SHARP**CATEGORY: Bc**

Technical Report

SUBJECT: ON TIMER FAULT

REF: SP010500X

R721
R703

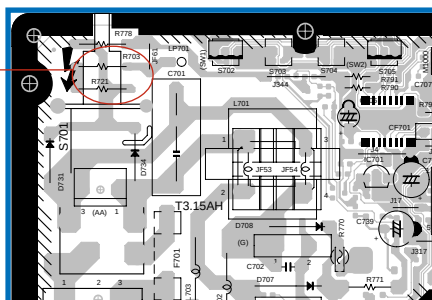
Have been detected that in some TV the ON TIMER fails at tensions over 220V. The reason of this fault is that the supply μ P slave is not stable over 220V AC.

REF No.	NEW PARTS DESCRIPTION	OLD PARTS NUMBER	NEW PARTS NUMBER	INTERCH-ANGEABI-LITY	EFFEC-TI VE FROM	CO-DE
R703	RES. 150K 1/2W	VRD-RA2HD4 74J	VRD-RA2HD154J	B	-	AA
R721	RES. 150K 1/2W	VRD-RA2HD4 74J	VRD-RA2HD154J	B	-	AA
